Wauwatosa, WI

Board of Public Works

Meeting Agenda

Wednesday, September 24, 2025

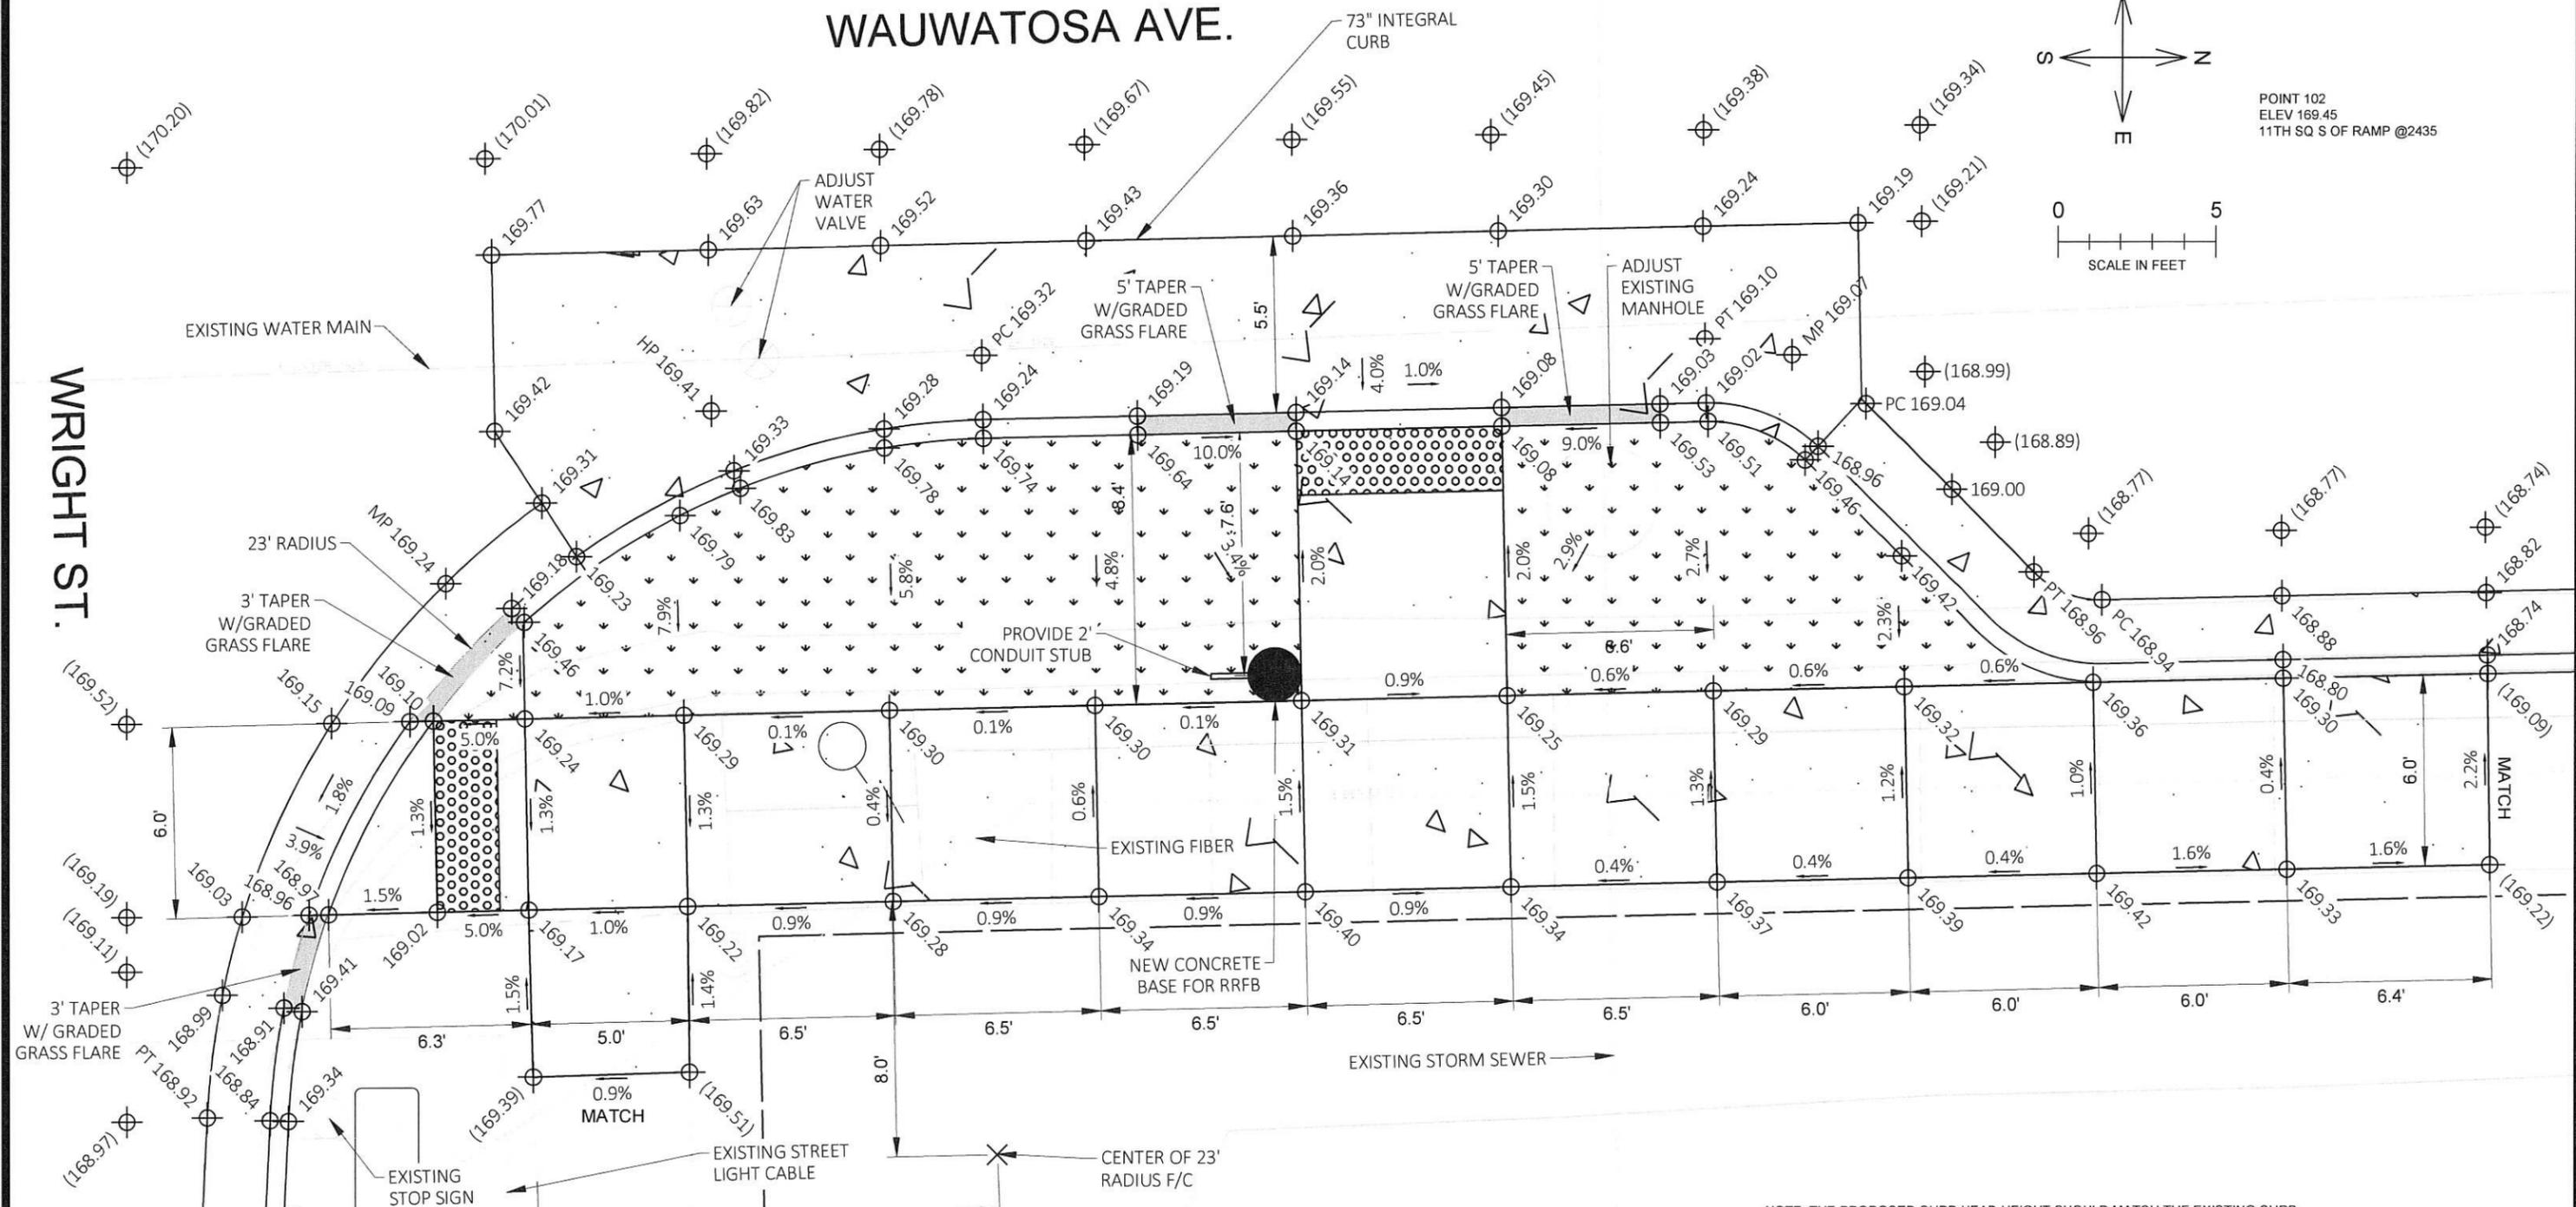
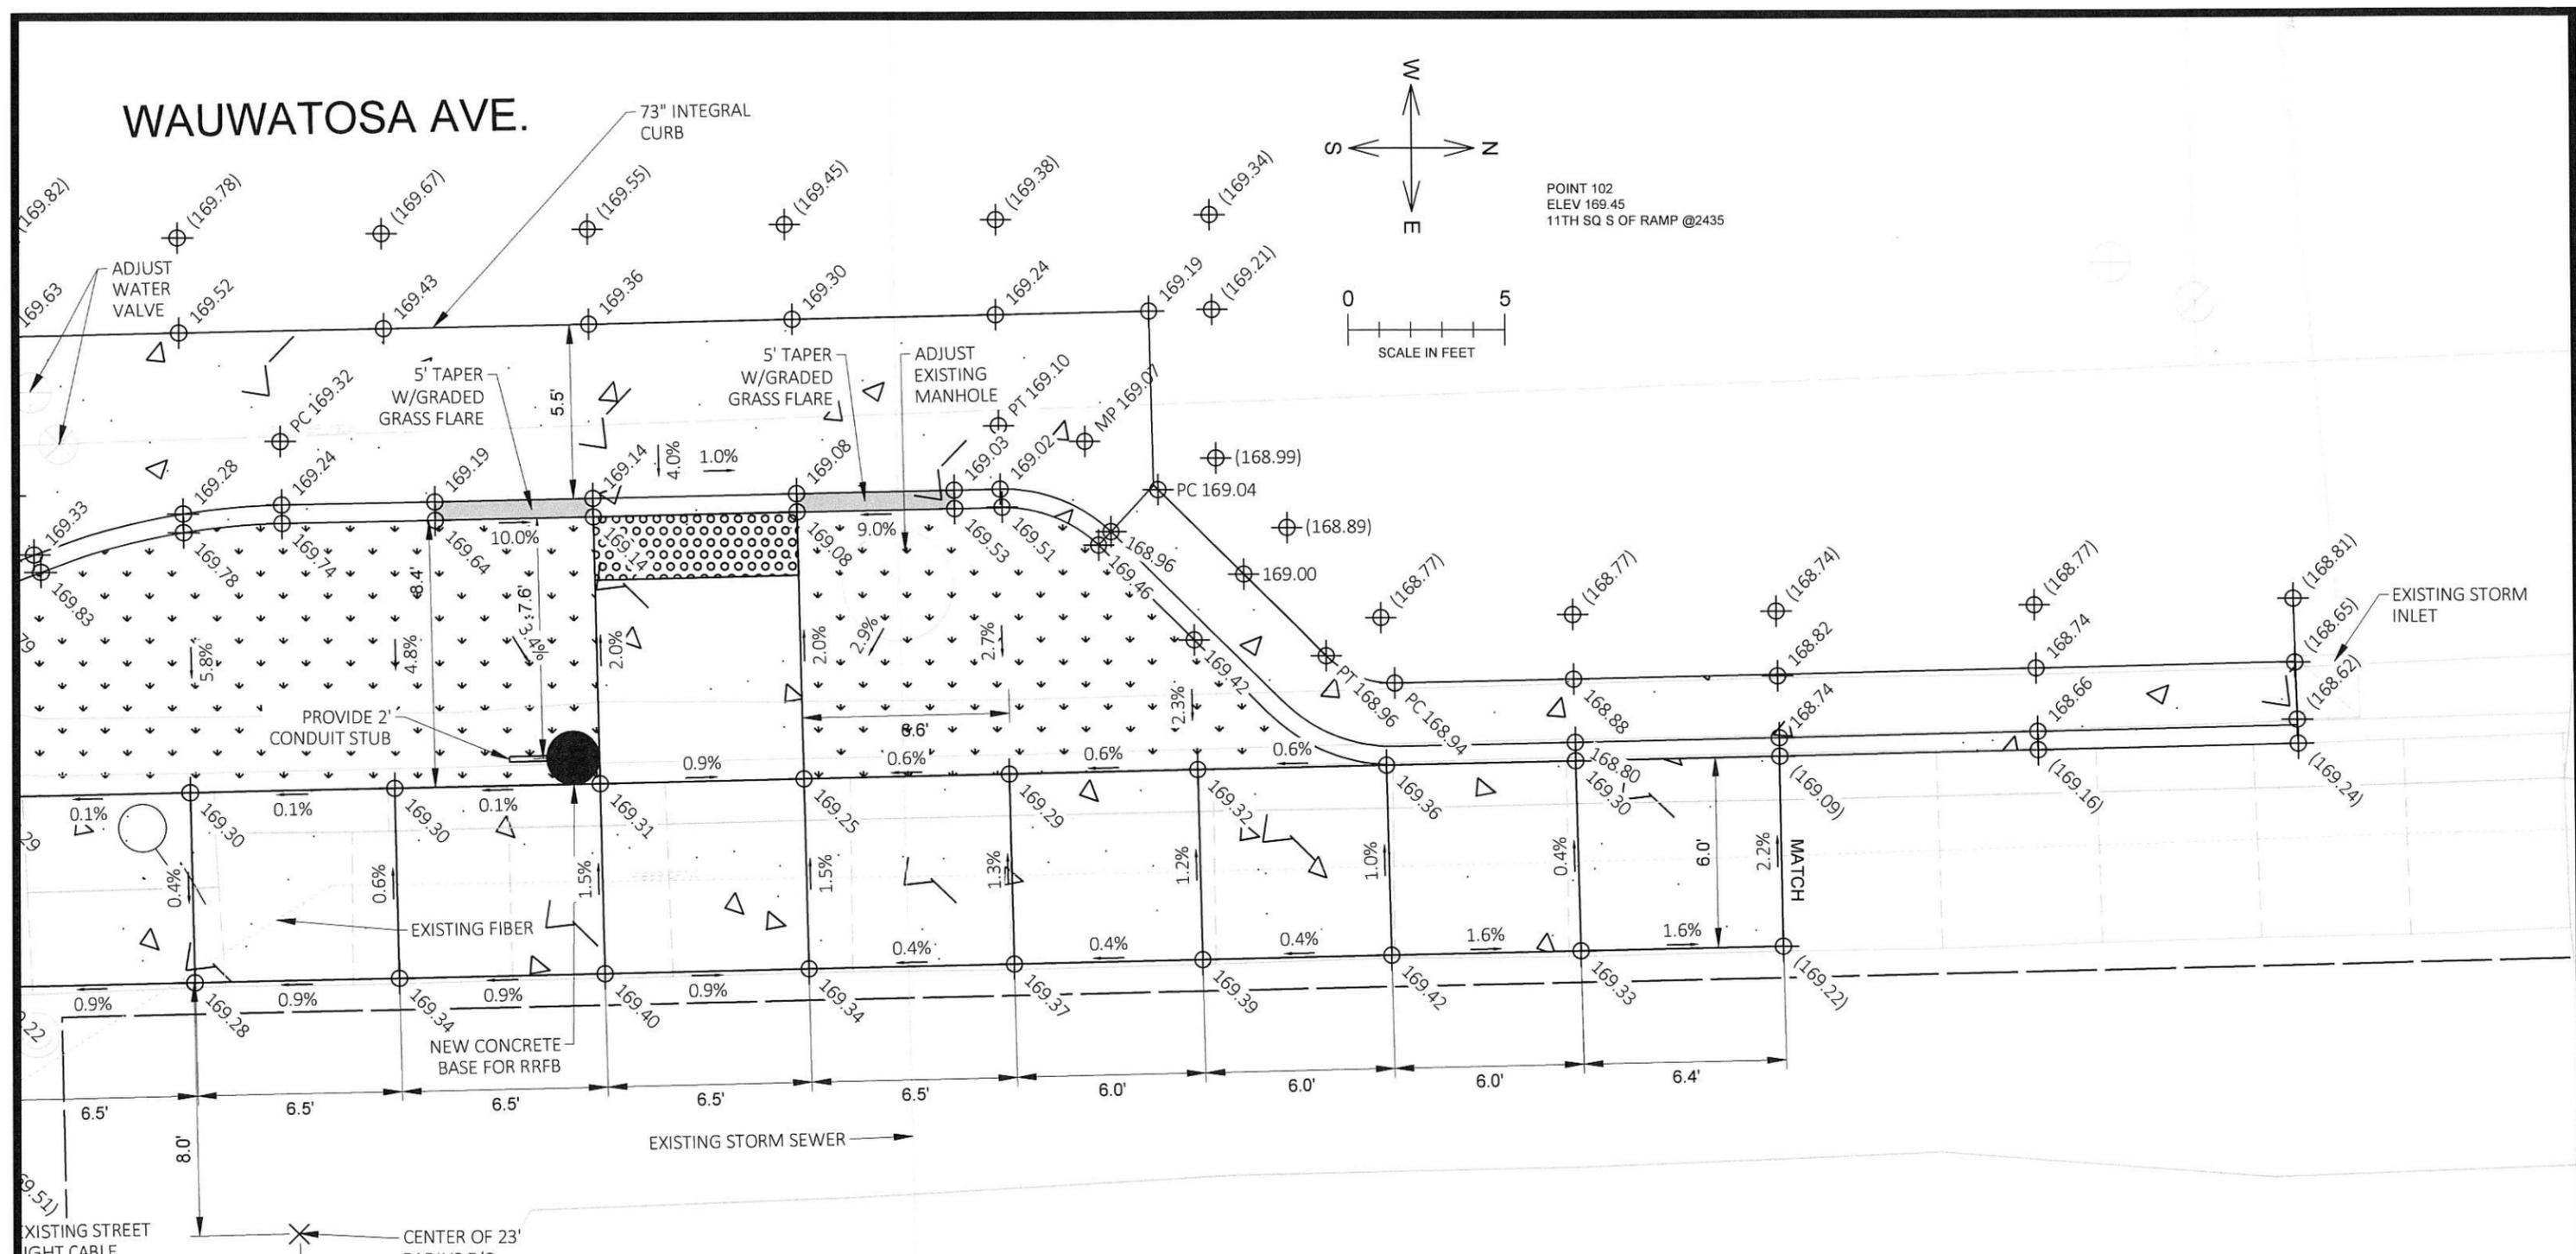
This Change Order (CO) is for new work that was added to Contract 25-19 after bidding. The work includes building a new curb bump out and two pedestrian ramps in the northeast corner of Wauwatosa Avenue and Wright Street as part of the City's new Traffic Calming Program, funded by the Vehicle Registration Fee. Plans and layout are included in the attachments.

CONTRACT MODIFICATION DESCRIPTION: Adding sidewalk ramp replacement at Wauwatosa Ave. and W. Wright St.

Add Wauwatosa Ave. & Wright St. ramp sheets.
